HTMSAC Minutes

Hockey Teeball Mens Shed Advisory Committee (HTMSAC)

Monday 10 November 2025 at 5.00 pm

6.1 Revised Concept Design – Future Car Park

Attachment One – Areas of Comment.

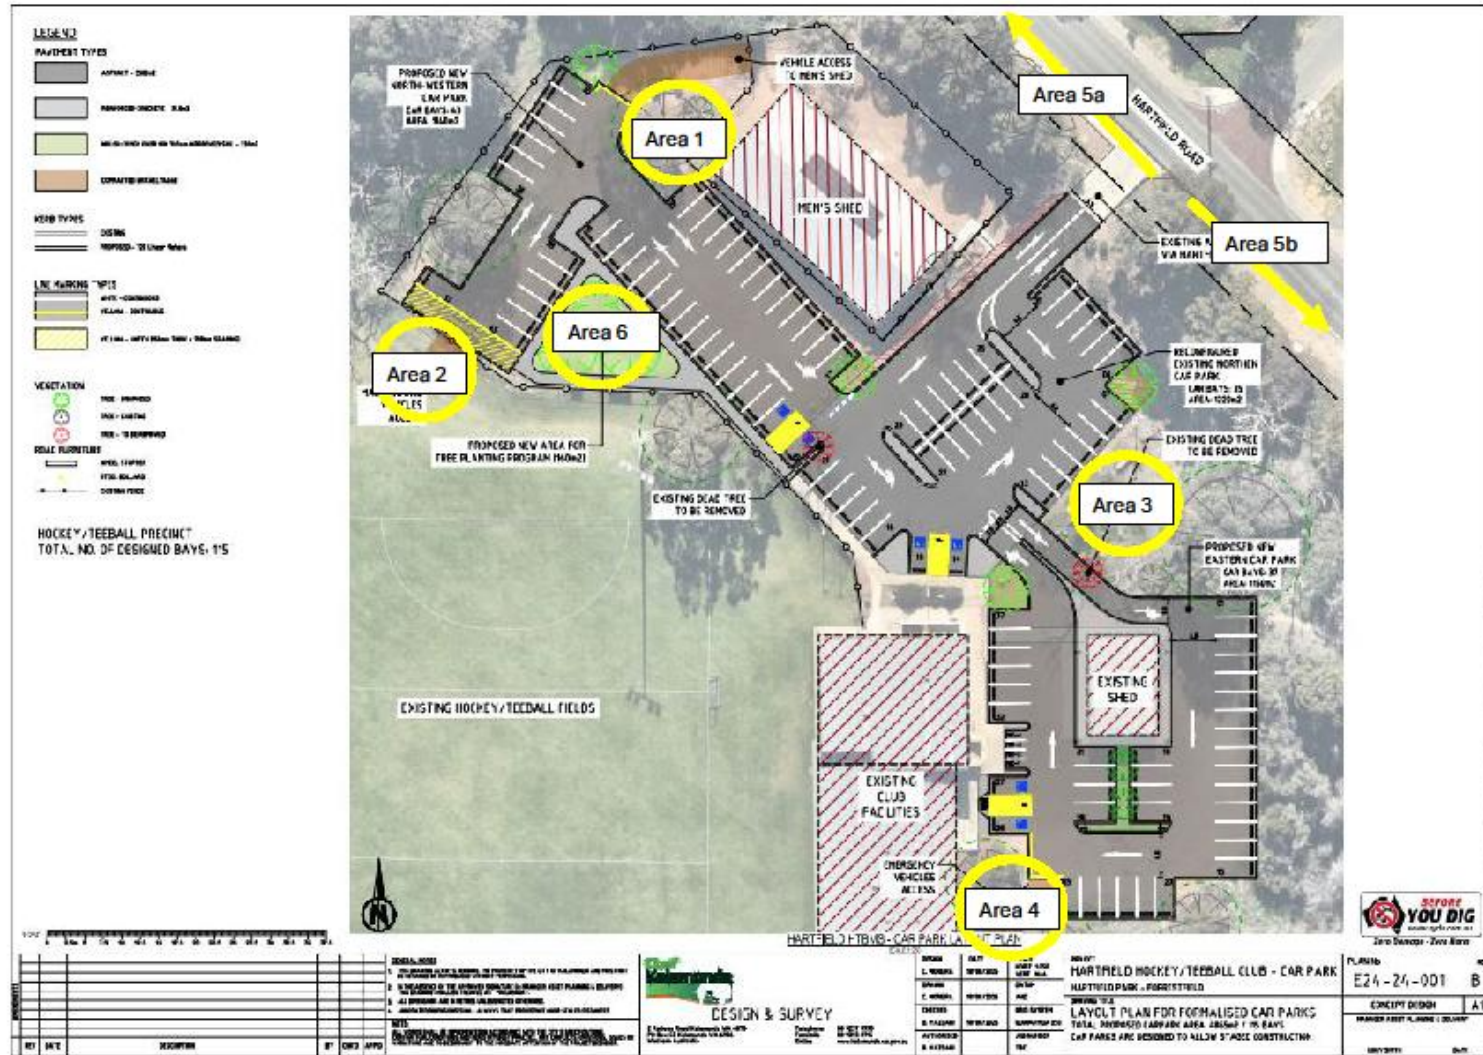
Area 1	Is there opportunity to consider informal parking in this space during Hockey and Teeball club timeslots	Trees in this area would require root zone protection, and it is the exit area for the FMS. Informal parking may be achieved as long as exit for FMS is not impacted. Trees would be protected by bollards as requested by City Natural areas Coordinator.	Two informal bays possible when Mens Shed not in use, with bollards installed to protect trees.	Noted	Nil
Area 2	Can fence line be adjusted to achieve more formal bays?	City would need to consider change in levels, possible services including drainage (culvert) and lighting conduit. Access to oval would also need to be moved which may reduce bays elsewhere.	An additional six bays could be achieved through extension of the car park into this space; however, at a significant cost as the areas are at different levels, cross a drainage culvert and there are services for irrigation and lighting in the location, thus increasing the cost to provide the additional bays.	Supportive of including in design if feasible and within budget.	Nil

Area 3	Can this area be considered for more formal parking? Remove young trees and formalise. Could provide 5-6 more bays	City advised that this may need to be considered by DWER for clearing but also additional Aboriginal Heritage Approval, as not included in existing Section 18. Redesign may only achieve	The current small trees can be removed and replacements offset. Six additional bays can be provided at this location. This meets Australian Standards, as a limit of six bays in such a configuration	Can more bays be added if an additional exit road was provided onto Hartfield Road?	City noted that additional bays with an exit road could be provided, however, the area is bushland and would trigger requirement for clearing permits. Noted that this area has also been identified as

4/5 bays due to access and manoeuvrability requirements.	allows cars to enter and reverse out safely without the need to provide a turning bay.		an area for offset for Main Roads WA along with other areas in Hartfield Park. Action; City to consider extension of bays and additional exit road and cost as part of the design.
Area 4	How many informal bays could be added here if gate adjusted?	City advised that this could be reviewed in line with discussion with Bushfire Mitigation Team.	This area is marked as an offset area for Main Roads for the Tonkin Highway projects. As such any informal parking will likely be planted out in the future. The area also links to the firebreak access and driveway for emergency vehicles and therefore should remain clear at all times.	Noted	Nil
Area 5a.	What offroad parking either formal or informal can be achieved along Hartfield Road?	"Line of sight" requirements, current footpath along 5a and slow points at 5b, do restrict any formal parking. City will consider opportunity for informal bays	5a – feature survey along Hartfield Road shows that existing trees are too close to allow installation of parking bays and a footpath.	5a - What is the need for the footpath along that section given there is already a footpath on the other side of Hartfield Road? Could bays be installed without the need to replace the footpath, thus not encroaching on the trees?	5a - City noted that the footpath was put in to connect the sporting areas. Footpath allows community access and also connects bicycles, prams and mobility scooters to the dog park and sporting facilities. Action 5a – consider need to retain footpath and review design if it is not required.

Area 5b			5b – Feature survey concluded that trees are too close to allow formal bays. Informal parking could be achieved with signage	5a and 5b – CR Cannon asked whether road verge be reclaimed on opposite side of road from facility and bays created? Or can the footpath become a shared vehicle / pedestrian space on weekends	Action 5b – consider how many informal bays with signage could be achieved and cost. 5a and 5b – This would be adhoc due to number of house driveways and retaining line of sight. May also cause issues with residents. Officers to investigate if the footpath can be a shared vehicle / pedestrian space on weekends.
Area 6	This triangle for planting could be used for additional bays, lost space?	City advised that due to the shape of the car park and need to retain the flow for ingress/egress of vehicles, this area needs to remain in place. Any changes would only reduce bays elsewhere.	Investigation found potential for a maximum 6 formal parking bays. However, 6 other bays had to be removed, so no gain in numbers. Not a cost-effective solution as increase Car Park footprint and likely causes access flow issues.	Noted	Nil
